# Detection and PSE SD Refinements

# Presentation Objectives

- To review a loophole that allows resistors to pass the existing detection scheme and propose a remedy (see comment 31).
- Propose changes that will make detection optional for PoDL PSEs that perform classification (see comment 30).
- Propose new PSE SD variables that will facilitate alignment between Clause 30 and Clause 45 and Clause 104 in response to unsatisfied D2.0 comment 333.

# Proposed Remedy for Detection Resistance Loophole

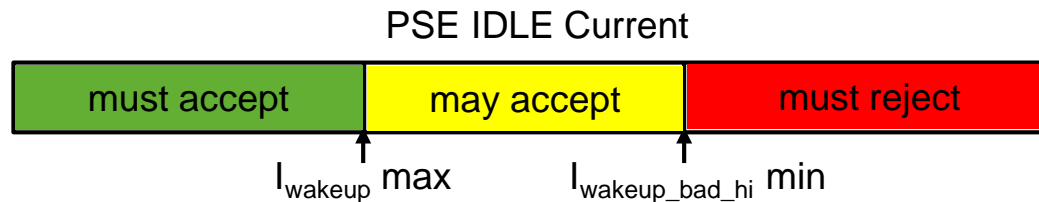
- Require that the PSE IDLE current be less than  $I_{\text{wakeup\_bad\_hi}}$  for at least  $T_{\text{Wakeup}}$  min before detection can begin.

- This test will prevent a resistor from being able to pass detection, i.e.

$$R_{\text{min}@PI} = \frac{V_{\text{Sleep, min}}}{I_{\text{Wakeup\_bad\_hi, min}}} = \frac{3.15\text{V}}{2.5\text{mA}} = 1260 \Omega$$

- Create new PSE SD diagram variable 'iprebias\_valid' that is asserted when  $I_{\text{PSE}}$  is valid during idle, and logically AND it with the existing expression governing the arc between the IDLE and DETECTION states.

# Proposal for Making Detection Optional for PoDL PSEs that Perform Classification

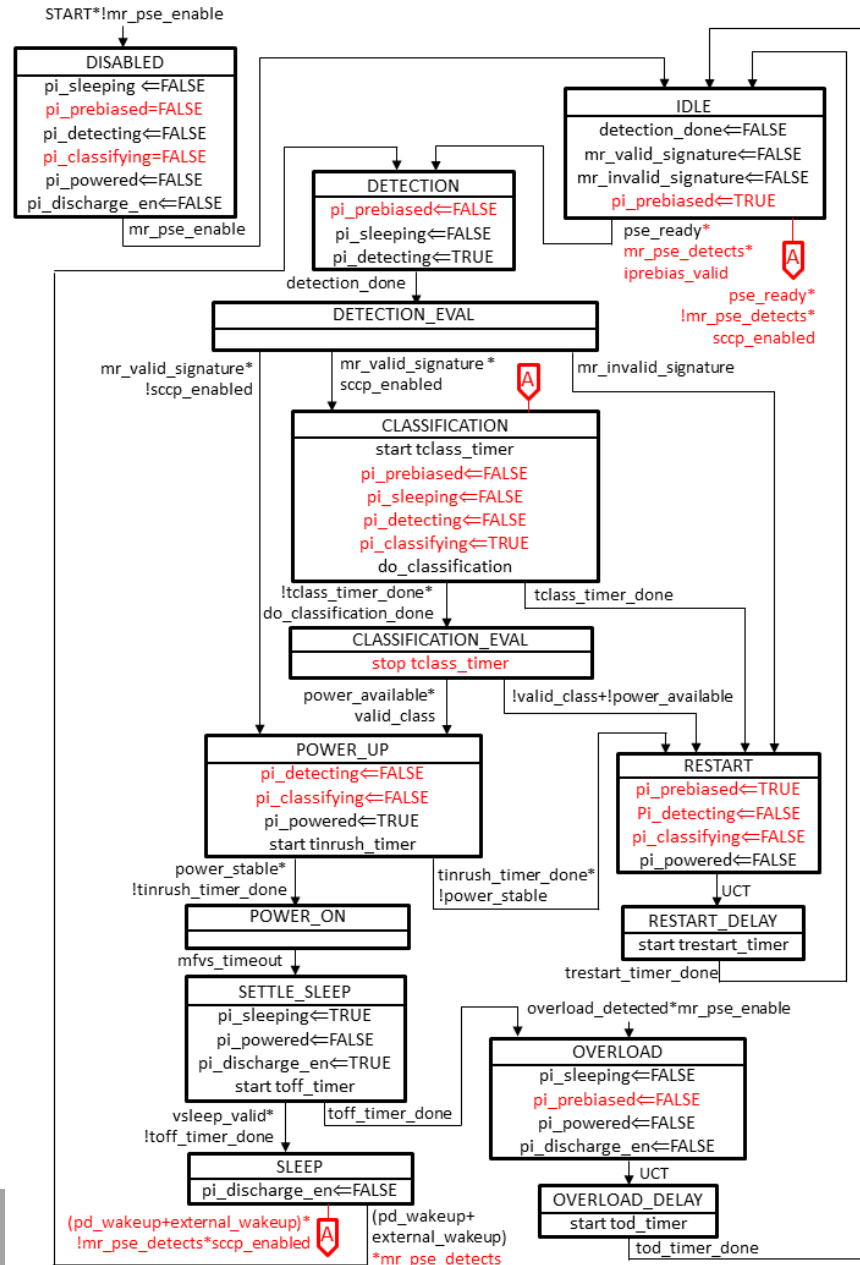
- By itself, SCCP is definitive about a valid PD being connected.
- SCCP uses low voltage swings with limited current and is benign.
- Hence physical detection is superfluous for PoDL PSEs that perform classification and should be optional.
